GENWAL RESOURCES, INC
CRANDALL CANYON MINES
C/015/032

CHANGE TO THE
MINING AND RECLAMATION PLAN
TO INCLUDE

MINE DISCHARGE WATER
IRON TREATMENT FACILITY

**NOTE: THIS SUBMITTAL IS A RESPONSE TO
DEFICIENCIES TO THE ORIGINAL SUBMITTAL
OF OCTOBER 13, 2009**

FIGURE 13A
INSTALLATION OF RE-ROUTED CULVERT UD-3
FRONT VIEW

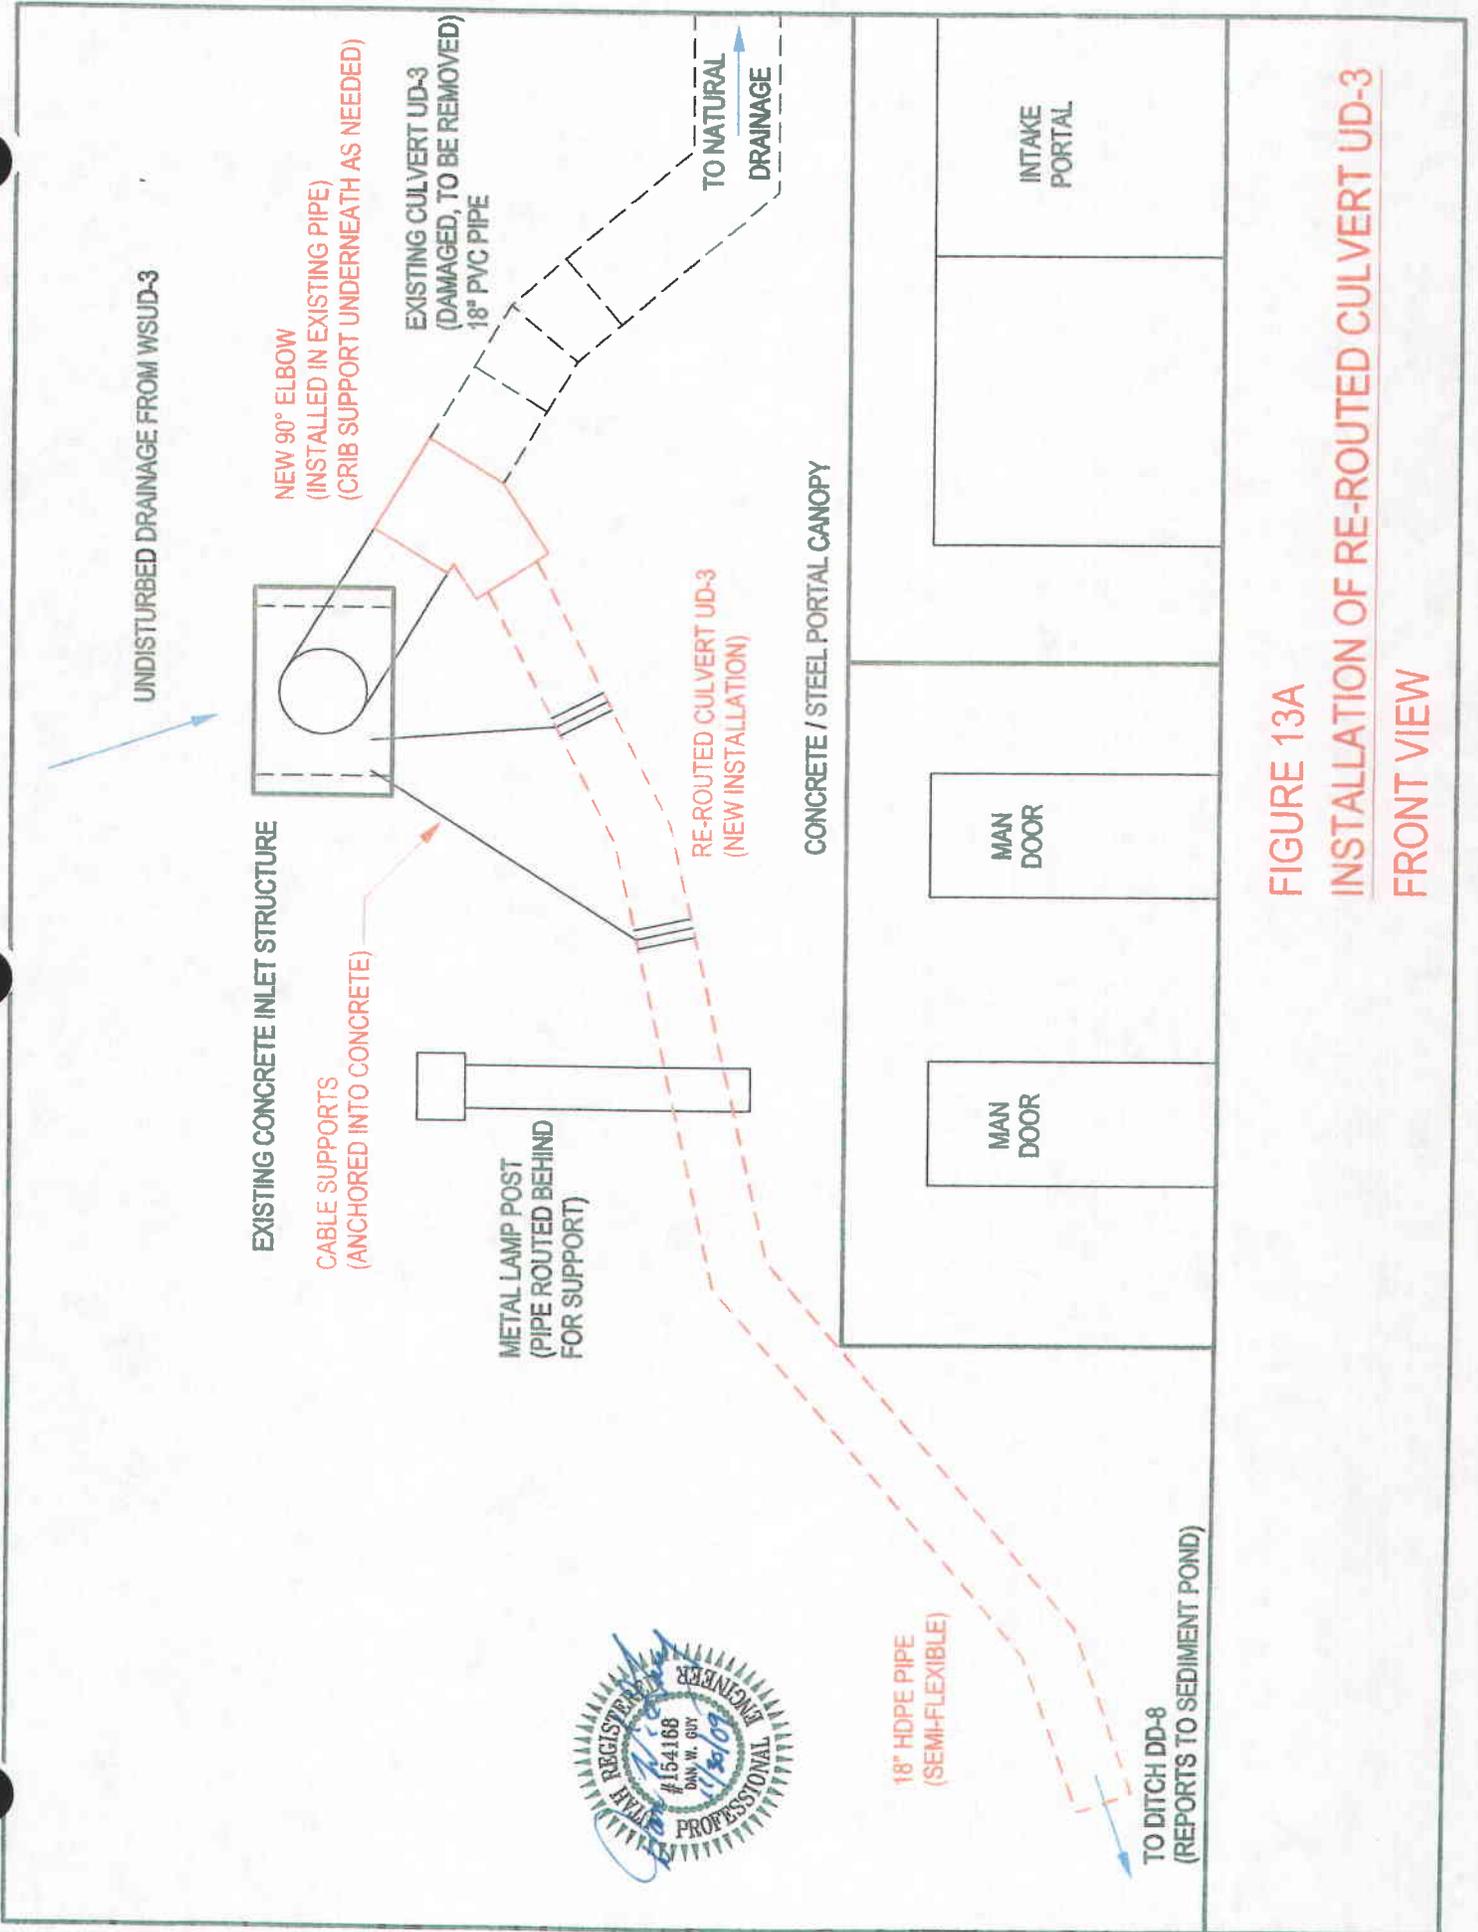
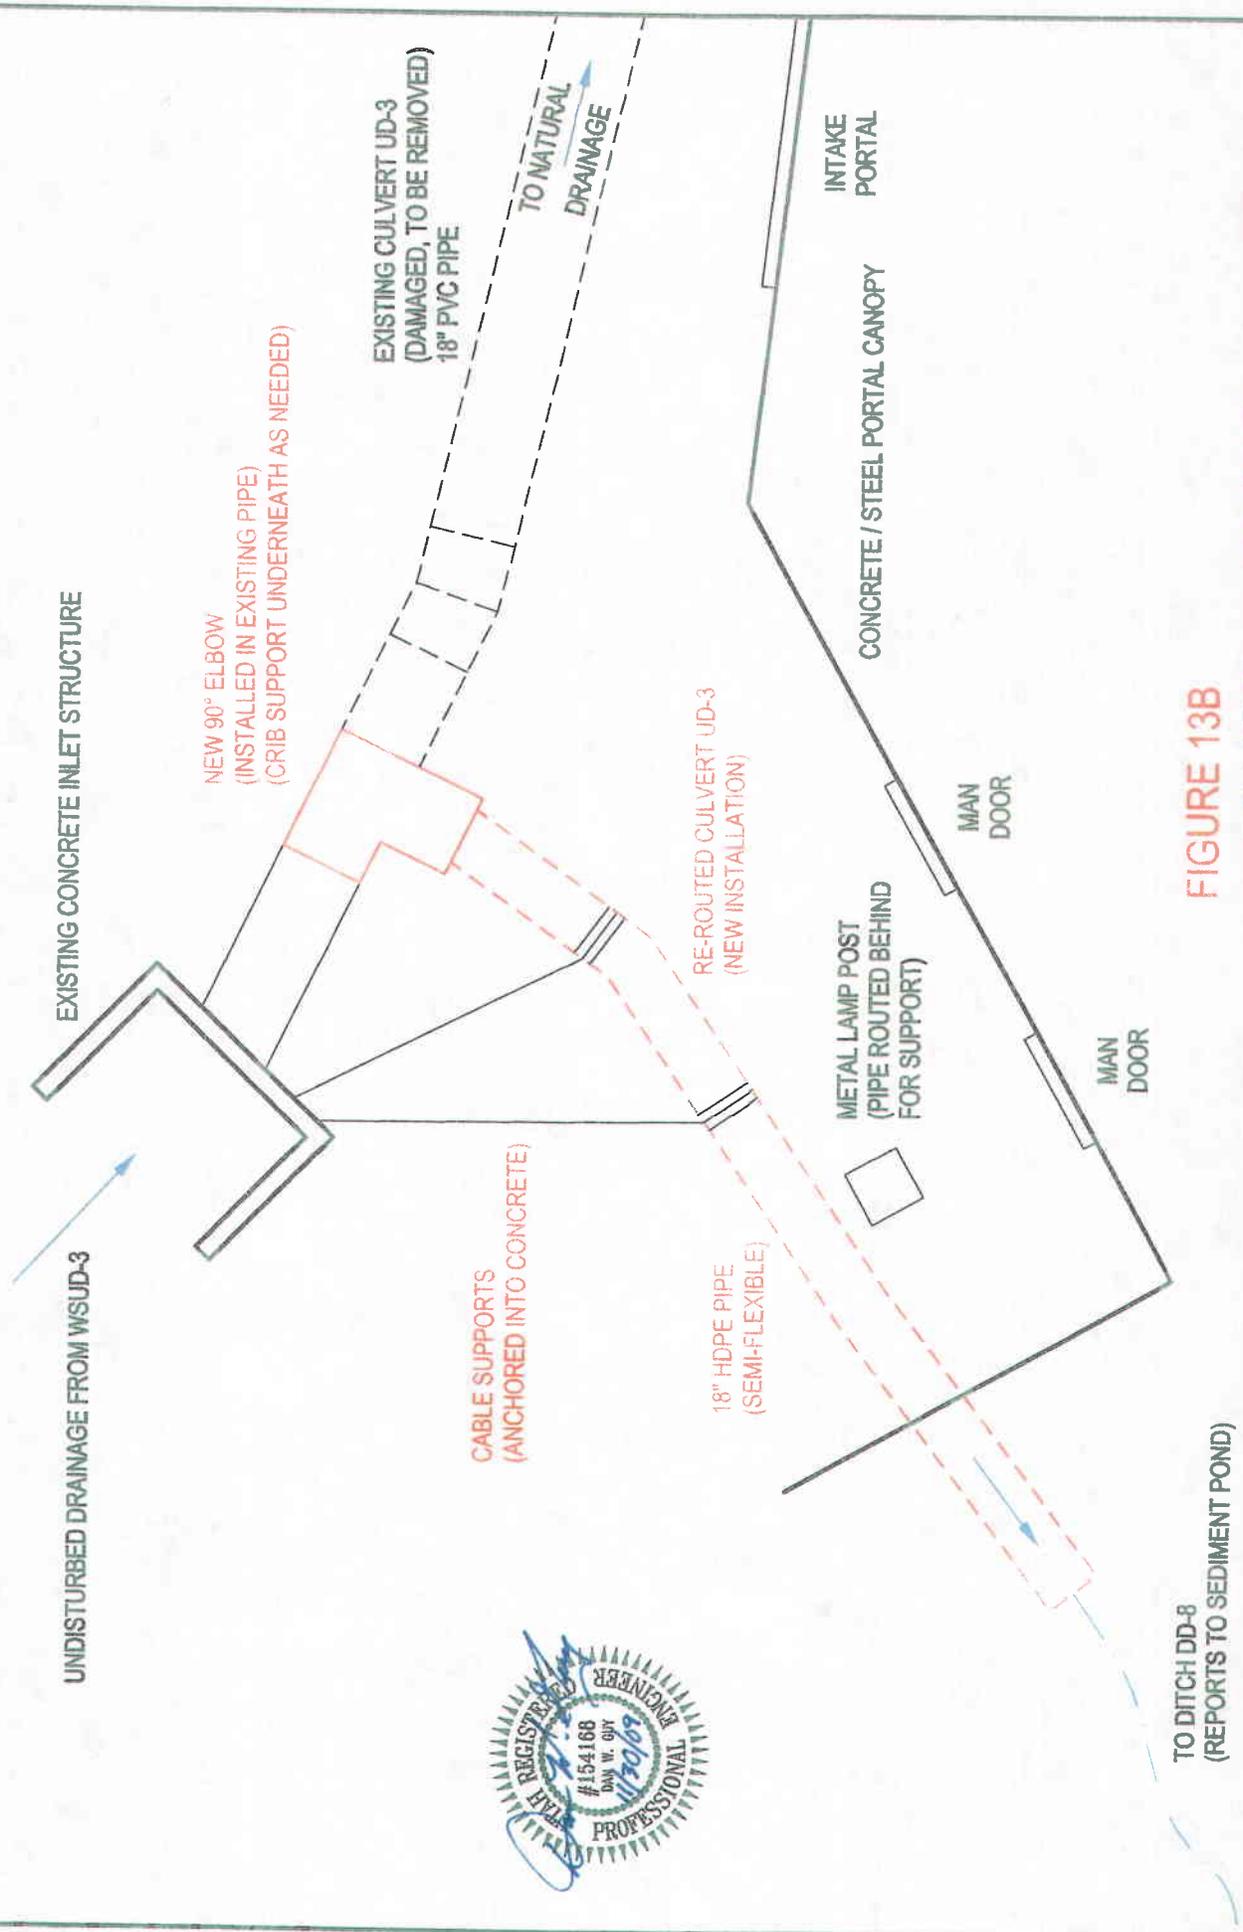
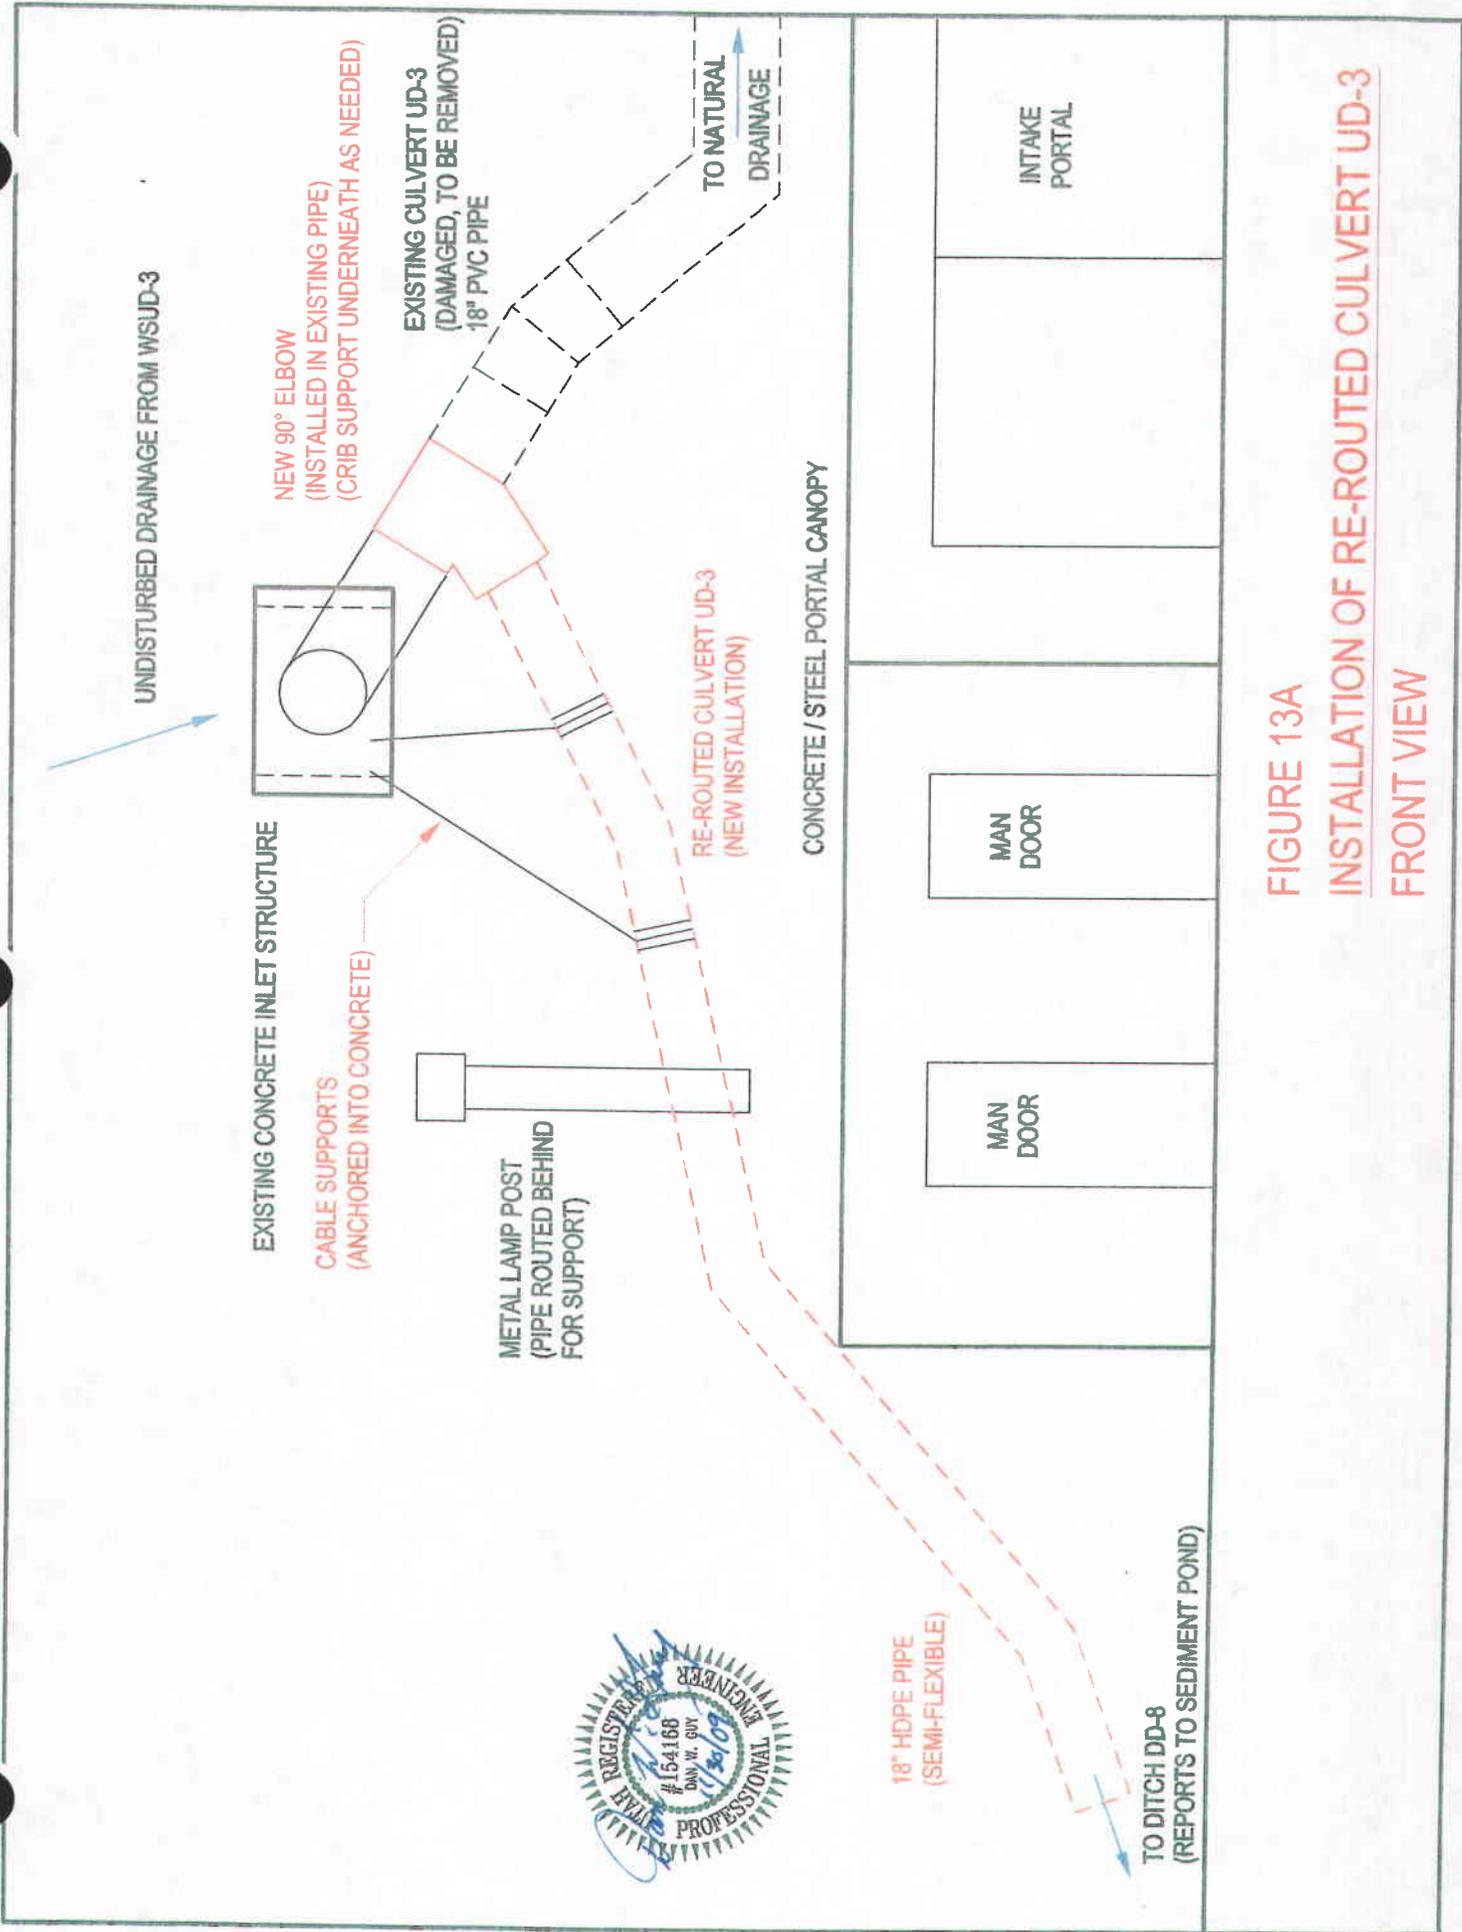
- (e) When the Crandall Canyon Mine Portals were sealed as a result of the 2007 disaster, culvert system UD-3 which diverts undisturbed drainage area WSUD-3, was damaged beyond repair. Therefore it was decided to re-route UD-3 as shown on Figures 13A and 13B. Culvert UD-3 now reports to Disturbed Ditch DD-8, Culvert C-1, Disturbed Ditch DD-5, Culvert C-12 and ultimately into the Sediment Pond. Calculations show that all affected ditches, culverts and the Sediment Pond are adequately sized to handle the increased flow from WSUD-3 (See Tables 3, 5, 6, 7 and 11).*

- (e) When the Crandall Canyon Mine Portals were sealed as a result of the 2007 disaster, culvert system UD-3 which diverts undisturbed drainage area WSUD-3, was damaged beyond repair. Therefore it was decided to re-route UD-3 as shown on Figures 13A and 13B. Culvert UD-3 now reports to Disturbed Ditch DD-8, Culvert C-1, Disturbed Ditch DD-5, Culvert C-12 and ultimately into the Sediment Pond. Calculations show that all affected ditches, culverts and the Sediment Pond are adequately sized to handle the increased flow from WSUD-3 (See Tables 3, 5, 6, 7 and 11).*
